Vermont Agency of Transportation

REQUEST FOR PROJECT REVIEW

Proj. Name and Number: Middlebury WCRS(23)

CONTRACT 1
FINAL PLANS
OCTOBER 2016

PROJECT NAME: MIDDLEBURY	
PROJECT NUMBER: WCRS(23)	
FILE NAME: z10g044key_plan_pl.dgn	PLOT DATE: 10/18/2016
PROJECT LEADER: A.P. GUYETTE	DRAWN BY: K.D. WENTWORTH
DESIGNED BY: J.A. WHITMORE	CHECKED BY: G.S. GOODRICH
CONTRACT BREAKOUT	SHEET 3 OF 116

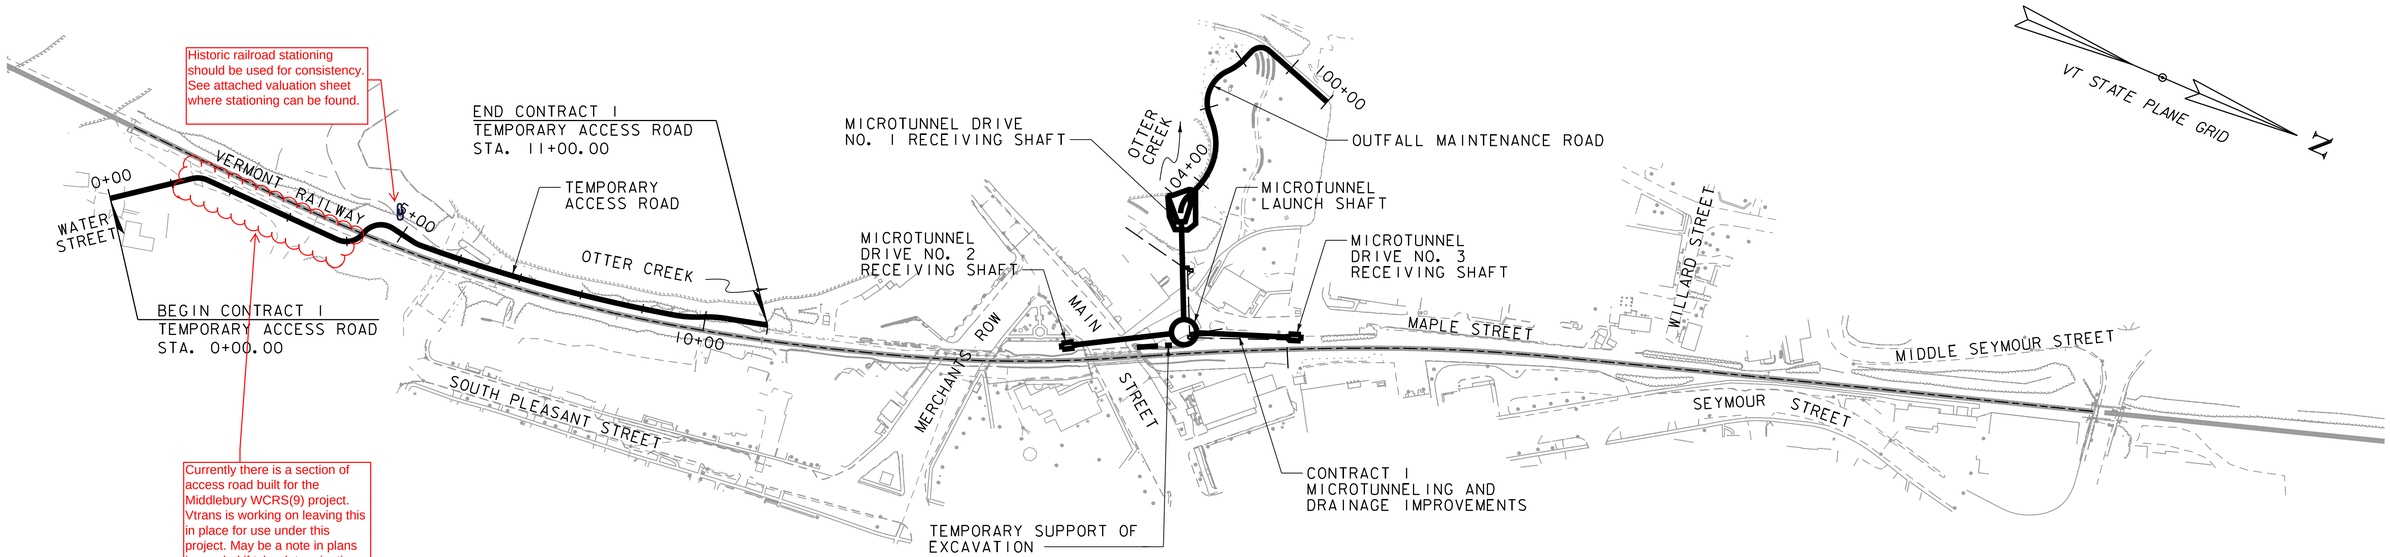
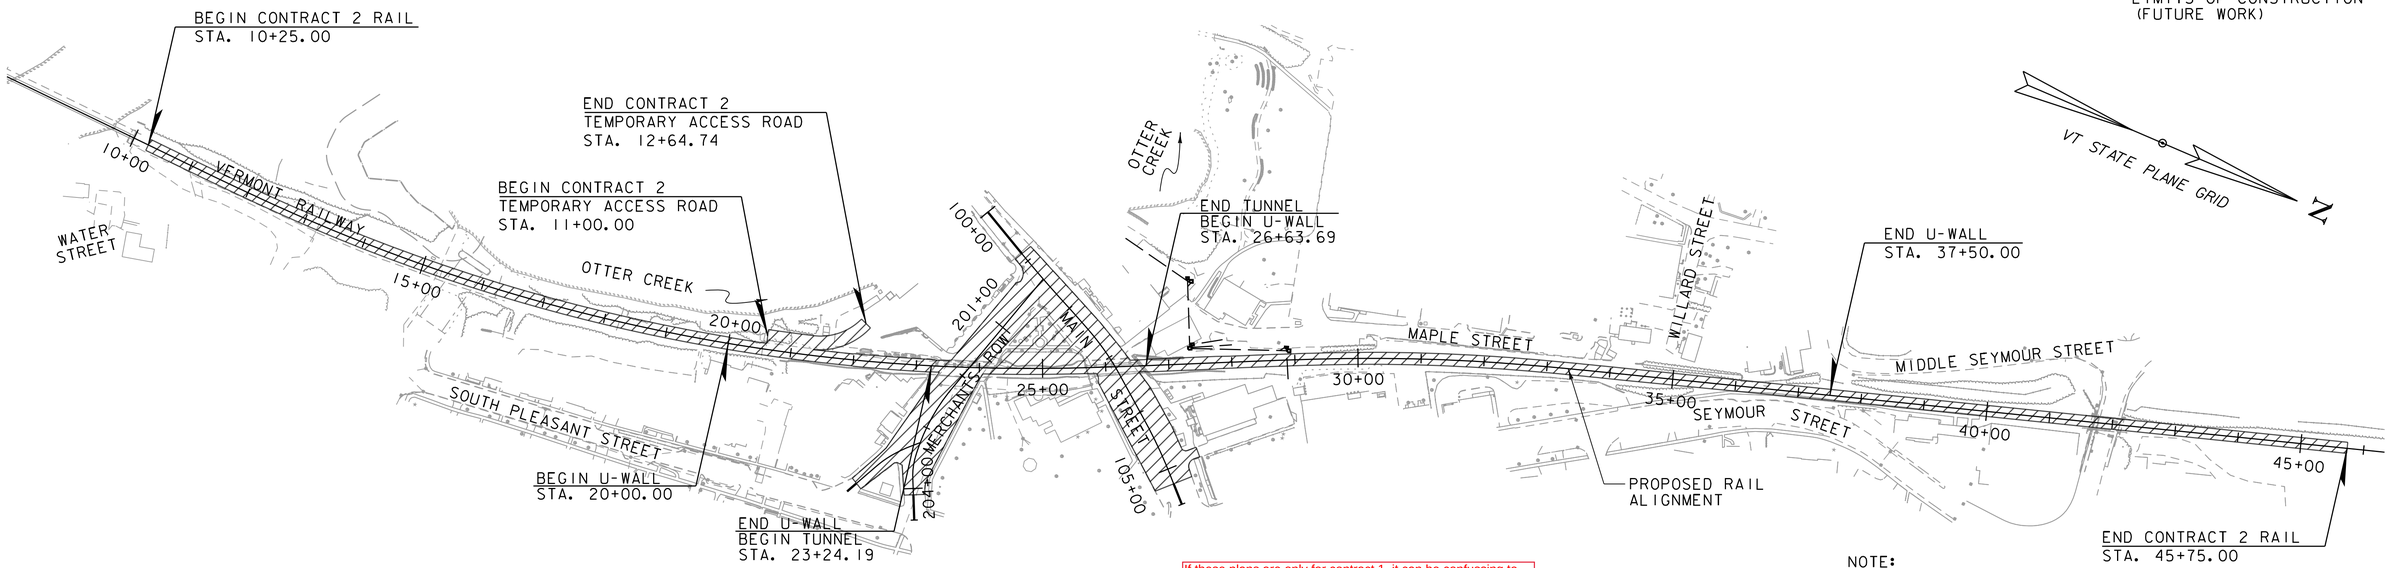
Historic railroad stationing should be used for consistency. See attached valuation sheet where stationing can be found.

Currently there is a section of access road built for the Middlebury WCRS(9) project. Vtrans is working on leaving this in place for use under this project. May be a note in plans is needed if tyhe determination to leave the access road in place is not made prior to these plans being finalized.

If these plans are only for contract 1, it can be confussing to have contract 2 shown. If you want to keep the contract 2 layout it would be better to place a box around it and shade it in.

Pavement needs to be added to C2 as contractor will use the road through 2018

PROJECT NAME: MIDDLEBURY	
PROJECT NUMBER: WCRS(23)	
FILE NAME: z10g044bdr_nul_pl.dgn	PLOT DATE: 10/18/2016
PROJECT LEADER: A.P. GUYETTE	DRAWN BY: K.D. WENTWORTH
DESIGNED BY: J.A. WHITMORE	CHECKED BY: G.S. GOODRICH
TEMP ACCESS RD LAYOUT SHEETS (1 OF 3)	SHEET 15 OF 116

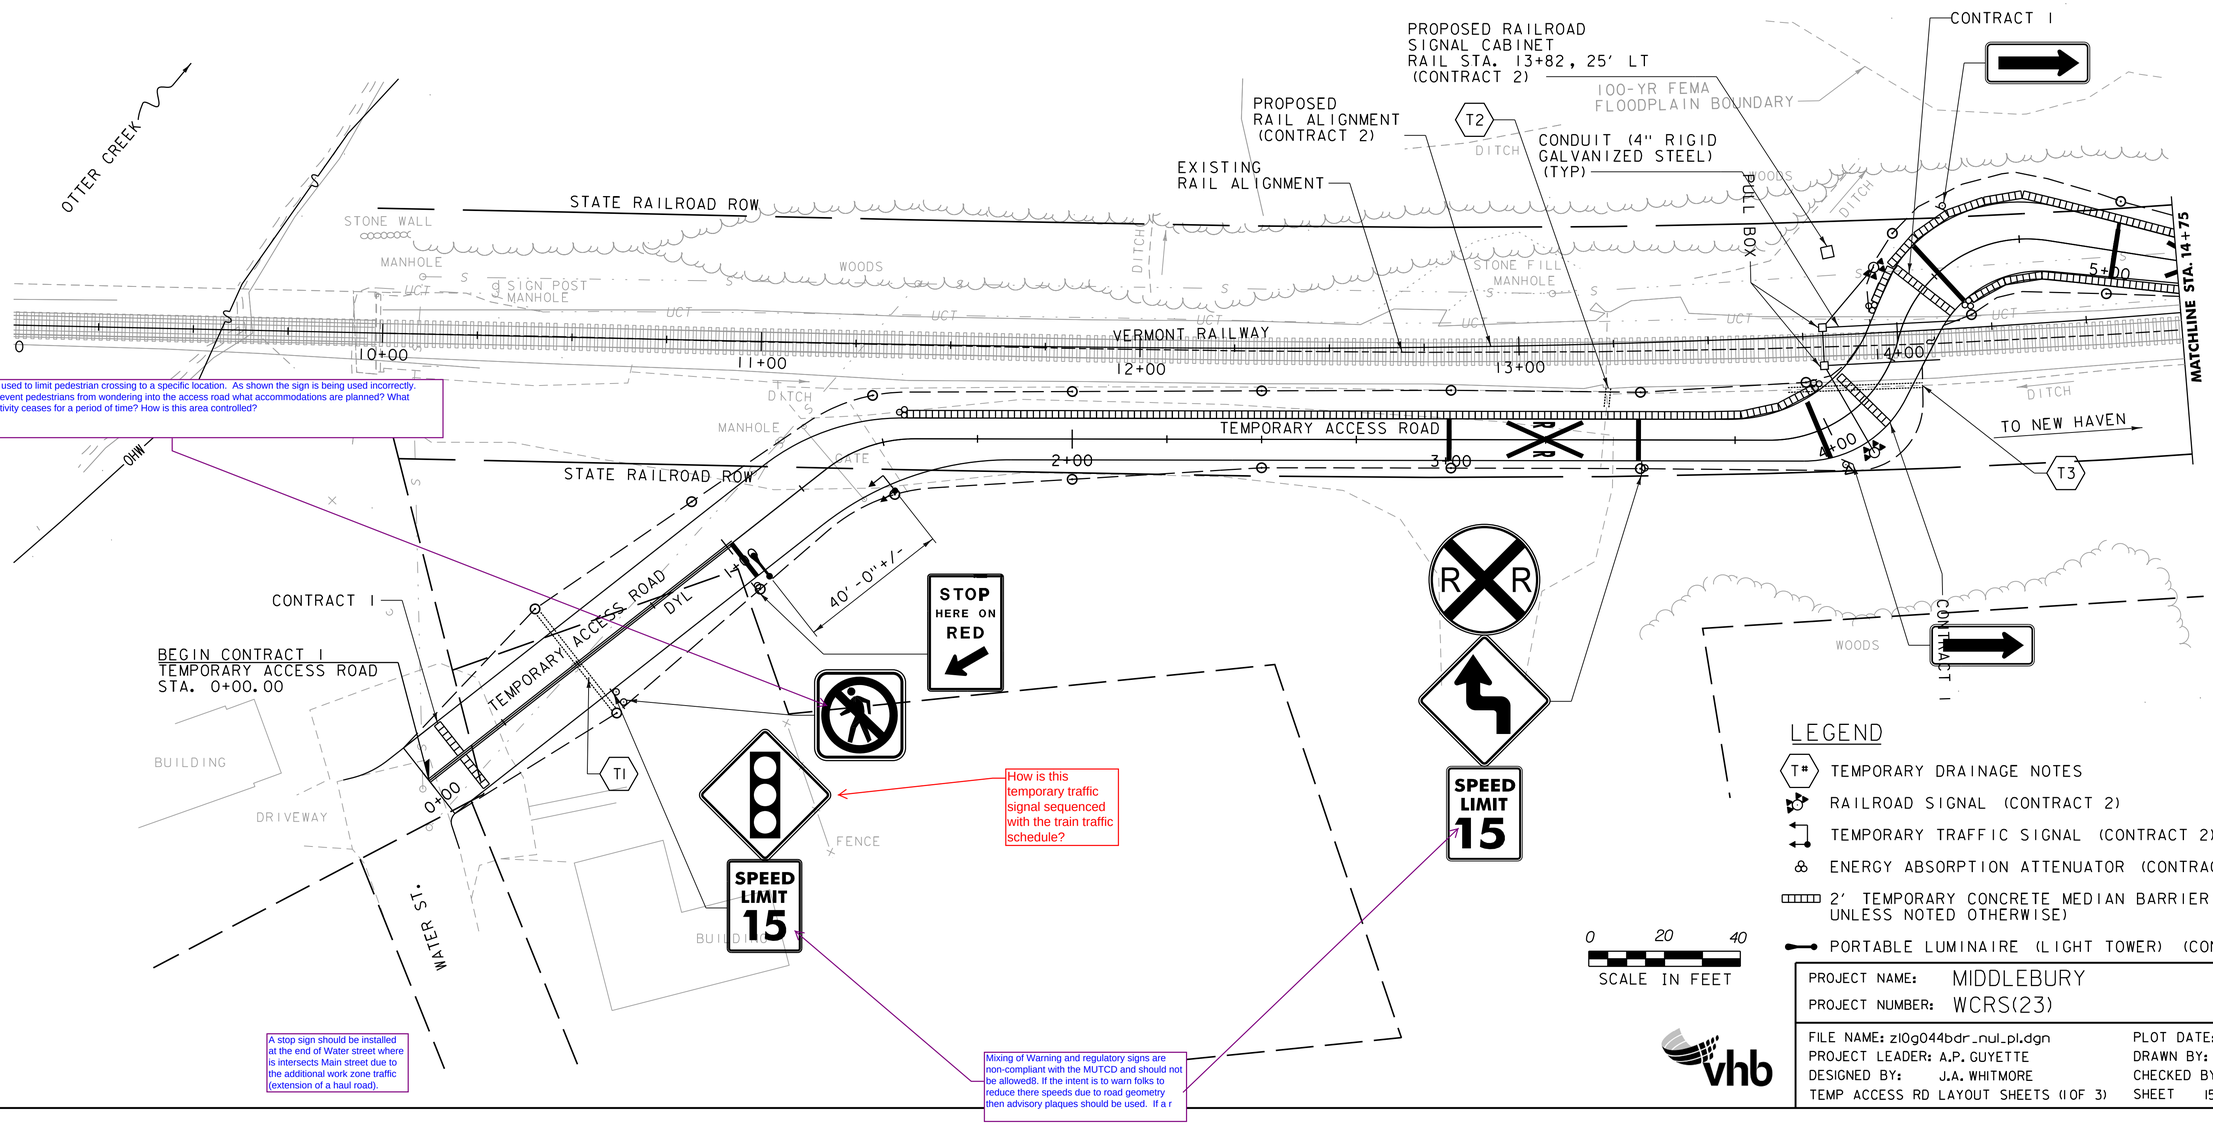
why including items specific to C2?

This sign is specifically used to limit pedestrian crossing to a specific location. As shown the sign is being used incorrectly. If the contractor is to prevent pedestrians from wondering into the access road what accommodations are planned? What happens when work activity ceases for a period of time? How is this area controlled?

How is this temporary traffic signal sequenced with the train traffic schedule?

MAIN STREET TEMPORARY BRIDGE PLAN

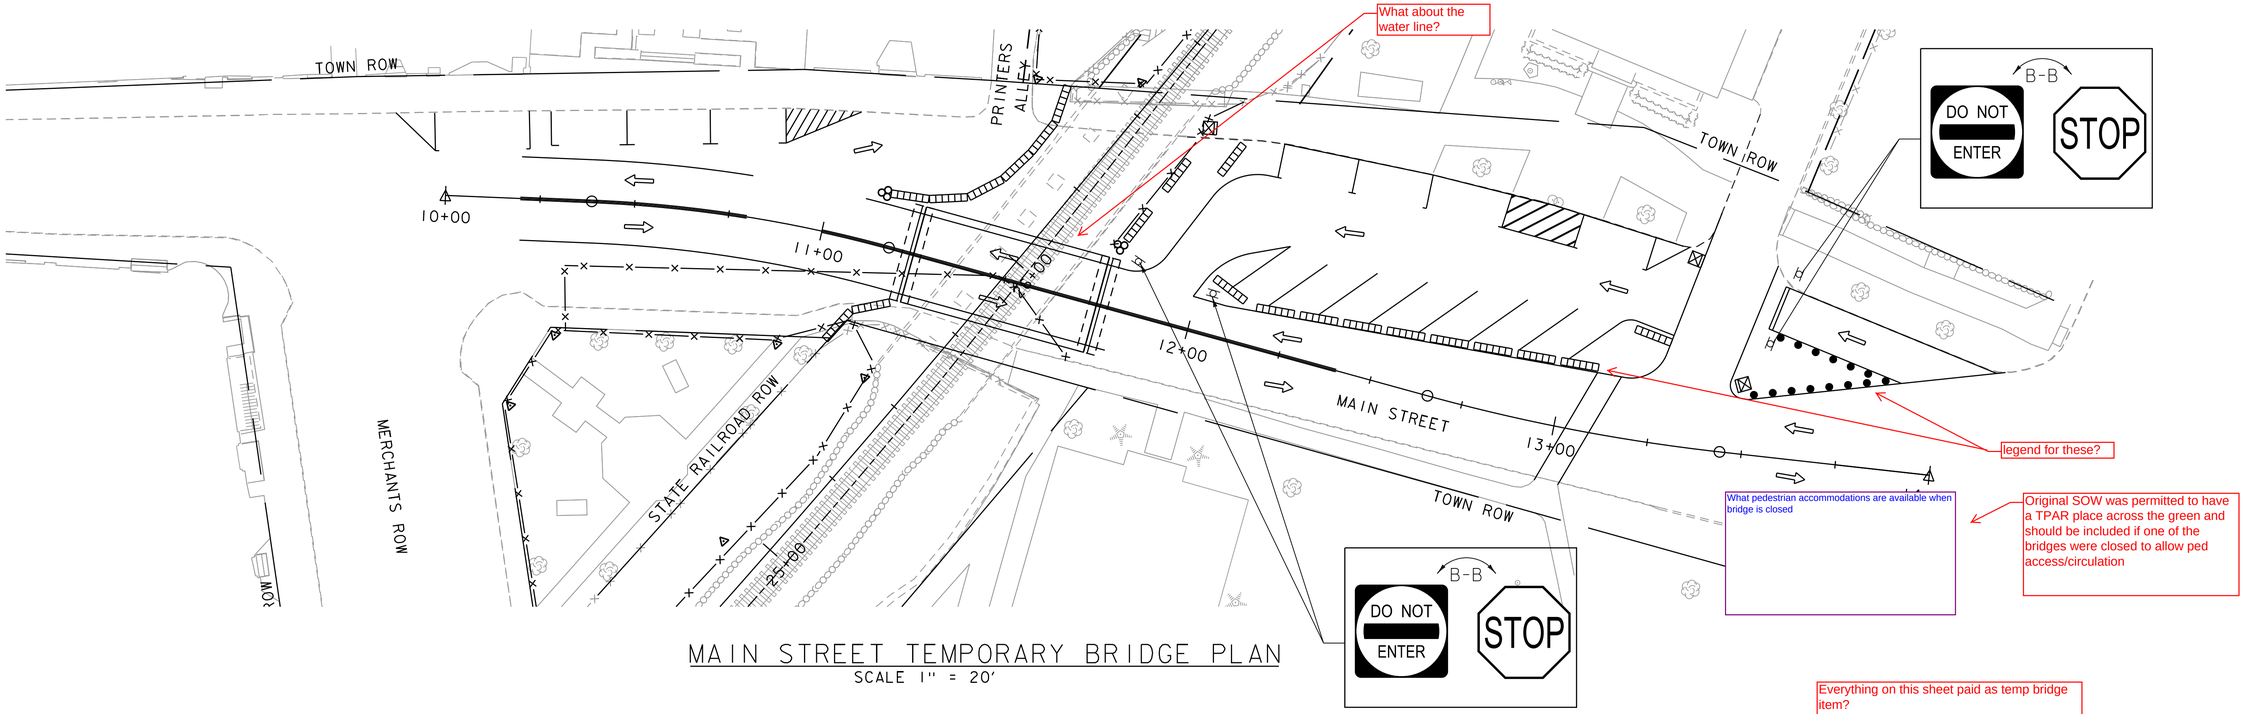
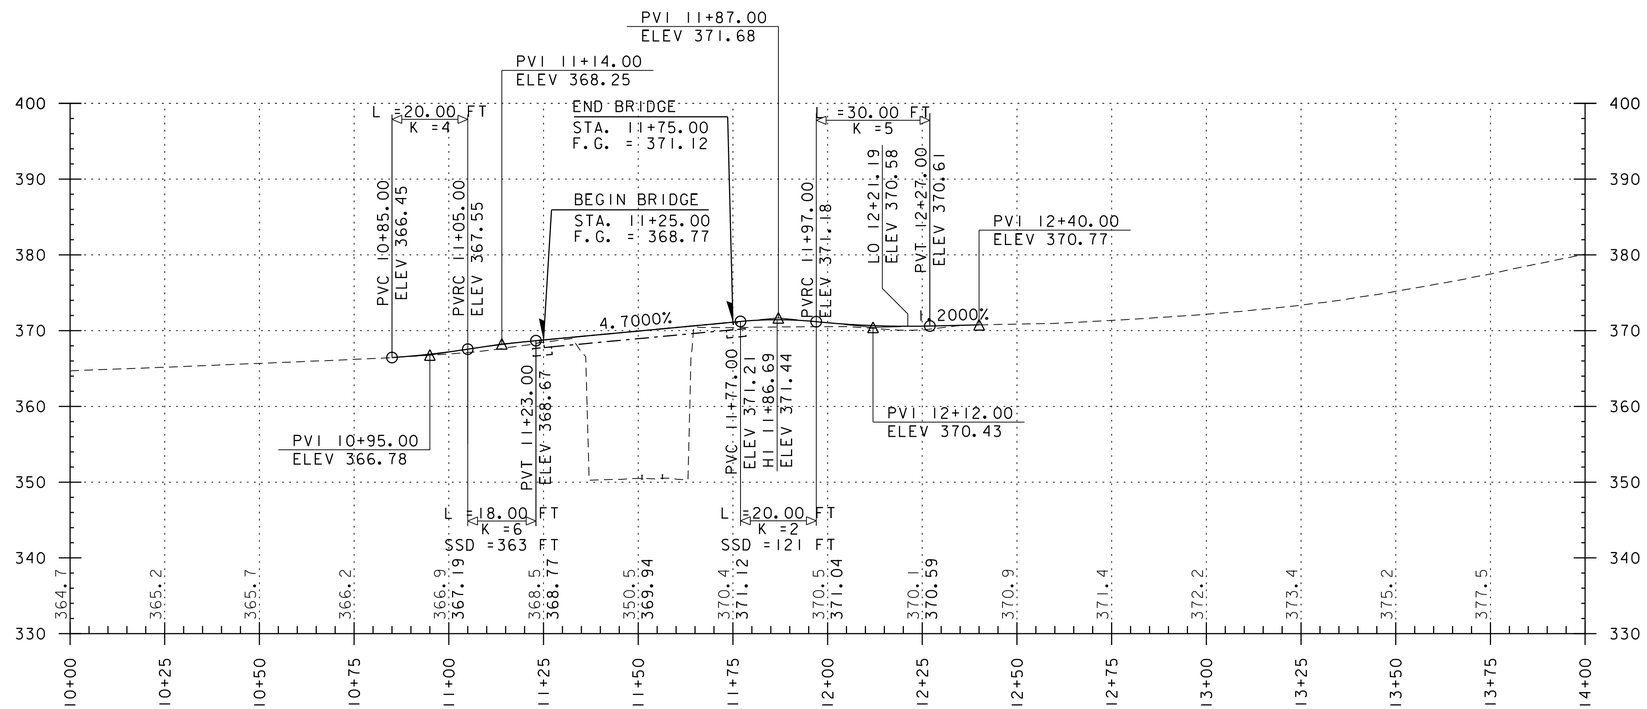
Everything on this sheet paid as temp bridge item?
Removal limits of existing bridge?

MERCHANTS ROW TEMPORARY BRIDGE PLAN

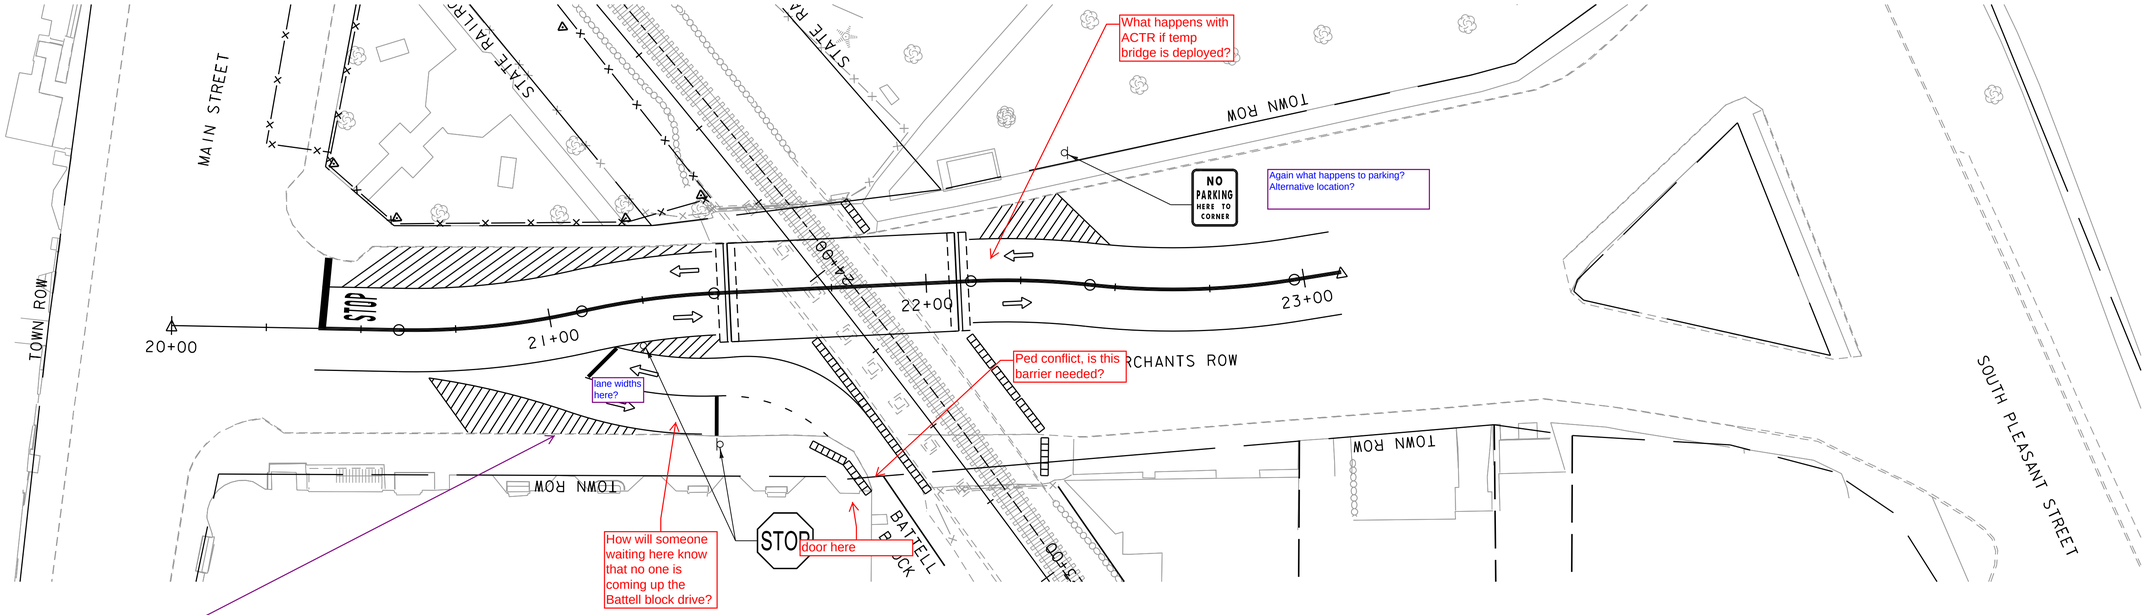
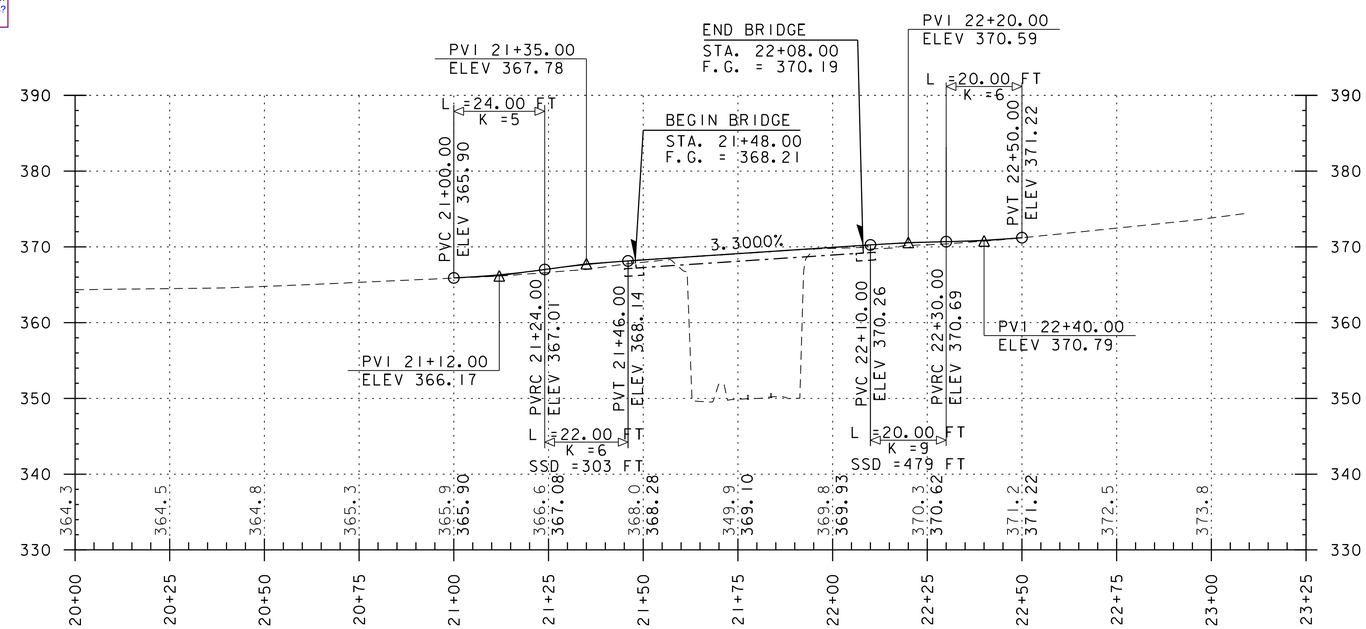
Public parking, businesses are not compensated for public parking. These temp bridge plans are more or less a contingency plan built into a construction project in the event that one of the bridges fail during the time that the contractor is under contract. They would be installed under emergency conditions.
